## Technical Memo

**To:** DSEL – Adam Fobert, P.Eng  
**Copy To:** File  
**From:** Lino Belgiorgio, P.Eng  
**Approved:** Peter Rüsçh, P.Eng  
**Date:** December 11, 2012  
**Subject:** Caivan – Richmond: Proposed Sump Pump Detail

### SUMP PUMP - DETAIL

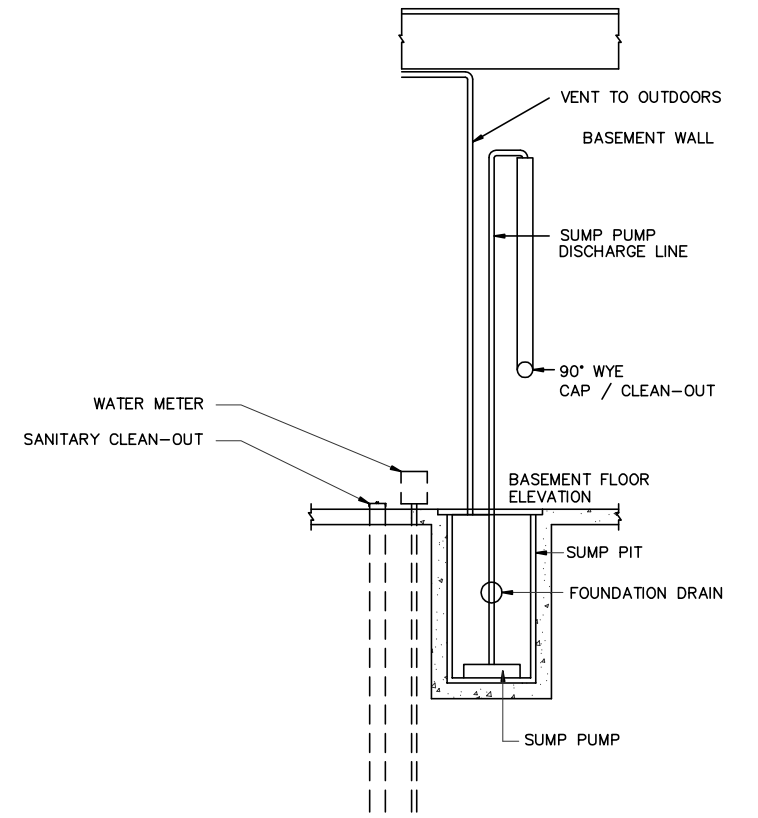
The proposed elevations are such that the discharge of the foundation drain via gravity to a culvert or a storm water drainage system is not possible.

The use of a sump pump located below the dwelling's basement floor, is proposed for the collection and discharge of the foundation drain flows.

We understand that soil conditions do not permit the discharge of the sump pump flows to the exterior ground surface or to a dry well system.

Consequently, the proposal is to discharge the sump pump flows to the storm drainage sewer via a 100 mm sewer pipe, extending from just inside the basement wall to the municipality's storm water sewer.

The 100 mm sewer pipe would terminate inside the basement with a 100 mm Y. The Y's straight leg would have a [screwed] cap for use as a cleanout.

The sump pump discharge will be connected to the Y's 45° leg and consist of 40 or 50 mm dia. pipe with a check valve, isolation valve and union.

The sump pump discharge would rise some 300 mm above the 100 year HGL before turning down and connecting to the sewer termination. Use of a backwater valve ahead of the 100 mm Y, is not considered necessary as potential backflow would be inhibited by the rise of the pump discharge elevation coupled with the sump pump check valve. The sump pump vent would terminate at the exterior of the dwelling.

Given that the pump discharge will be from a 40 or 50 mm pipe to a 100 mm pipe, there will be a free air surface at the junction of the Y connection, therefore siphoning will not be an issue. Provided a pump has been selected to operate within the preferred operating range [fairly close to best efficiency point], the sump pump arrangement will work as intended.
